Project	<b>IEEE 802.16 Broadband Wireless Access Working Group</b> < <a href="http://ieee802.org/16">http://ieee802.org/16</a> >	
Title	<b>Changes on Sleep Mode SDLs and MSCs</b>	
Date Submitted	<b>2004-1-8</b>	
Source(s)	Chulsik Yoon, Jaeheung Kim, Kunmin Yeo ETRI 161 Gajeong-Dong, Yuseong-Gu, Daejeon, Korea	Voice: +82-42-860-6826 Fax: +82-42-860-6732 mailto: <a href="mailto:csyoon@etri.re.kr">csyoon@etri.re.kr</a>
Re:	This is a response to a Call for Comments IEEE 802.16e-03/58 on IEEE 802.16e-03/07r5	
Abstract	This document contains suggestions to change the SDLs and MSCs reflecting working groups agreements on the Sleep Mode operation.	
Purpose	The document is submitted for review by 802.16e Working Group members.	
Notice	This document has been prepared to assist IEEE 802.16. It is offered as a basis for discussion and is not binding on the contributing individual(s) or organization(s). The material in this document is subject to change in form and content after further study. The contributor(s) reserve(s) the right to add, amend or withdraw material contained herein.

# Changes on Sleep Mode SDLs and MSCs

## 2. Proposed changes on Sleep Mode operation SDLs and MSCs in IEEE 80

Figure D.13 – Sleep Mode – MSS initiated awakening

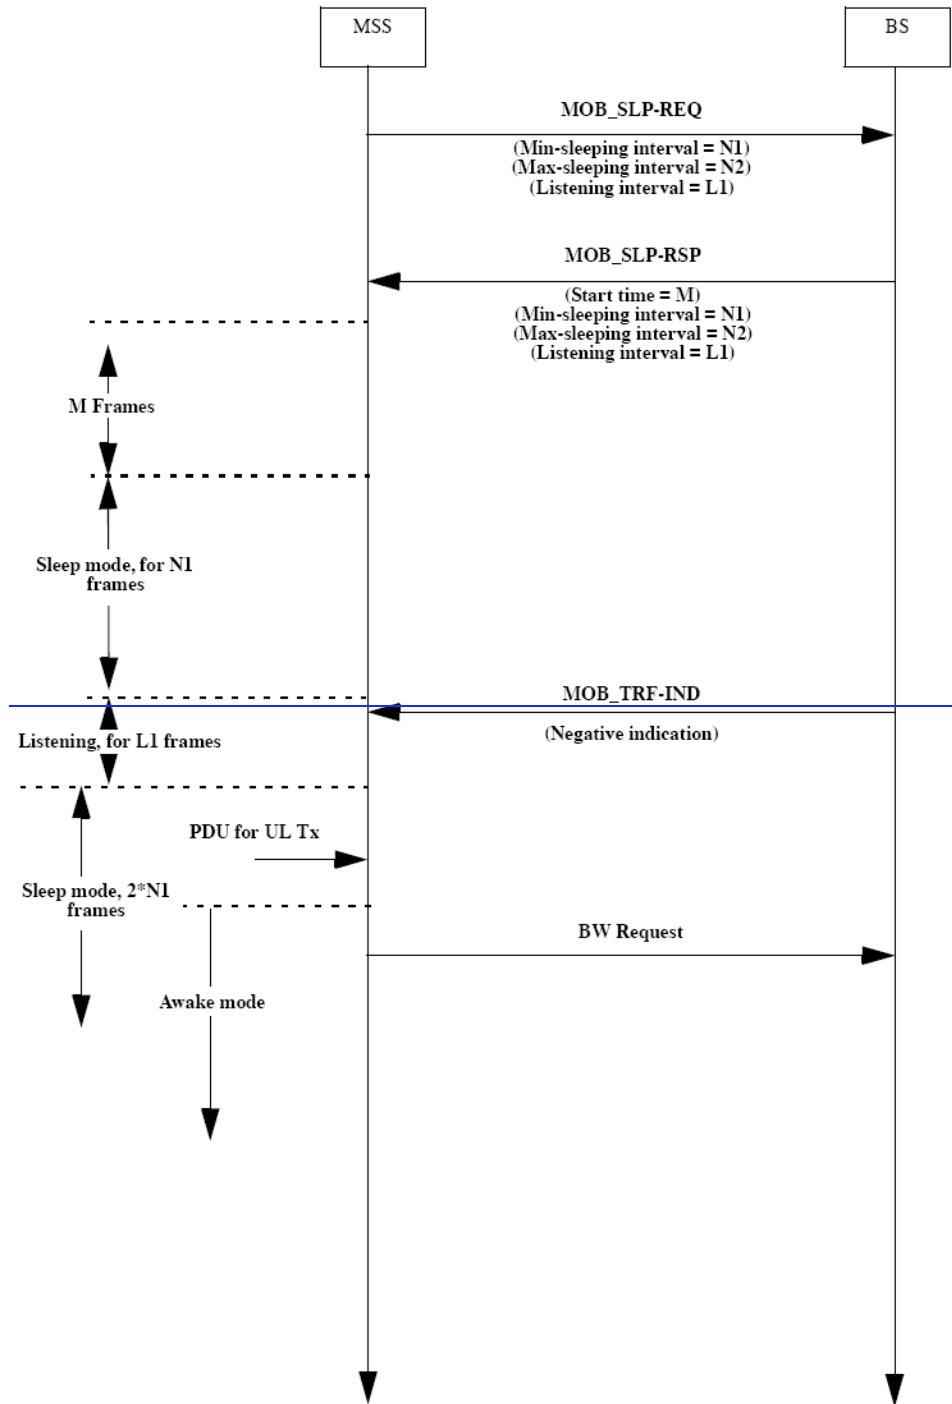
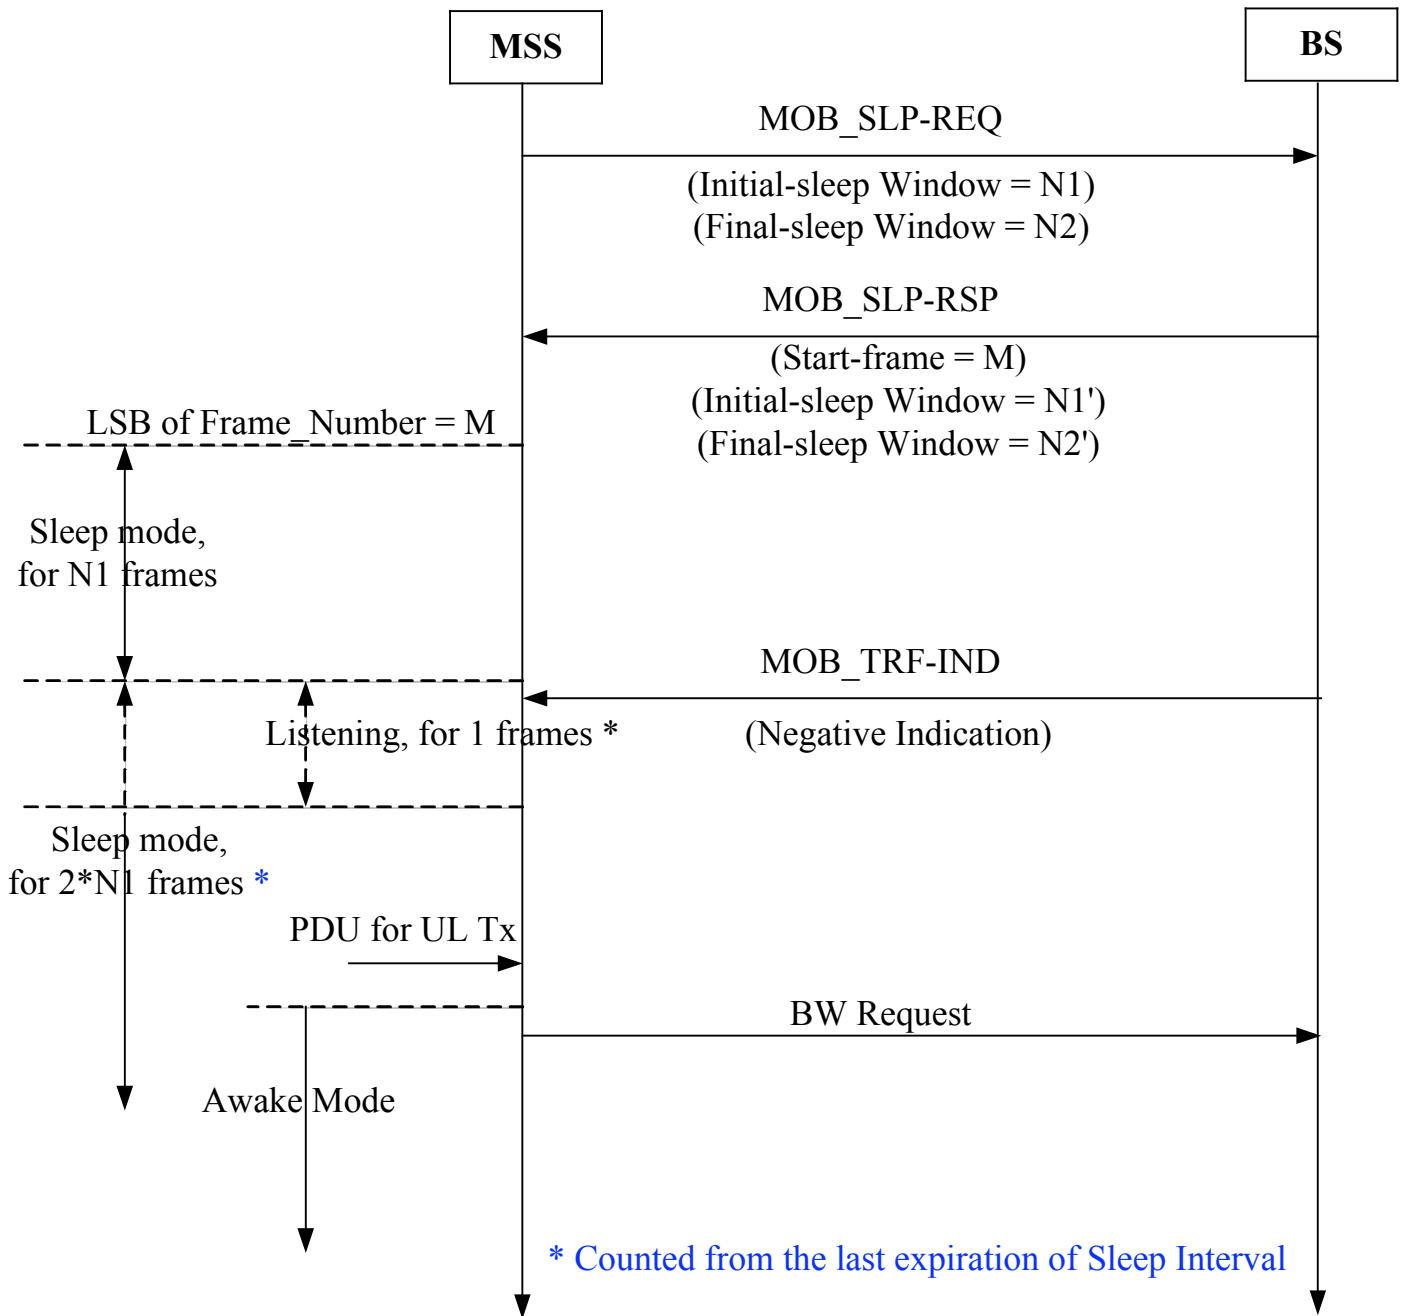
[Replace Annex D.2 Figure D.13 to the following:]  
 [From:]
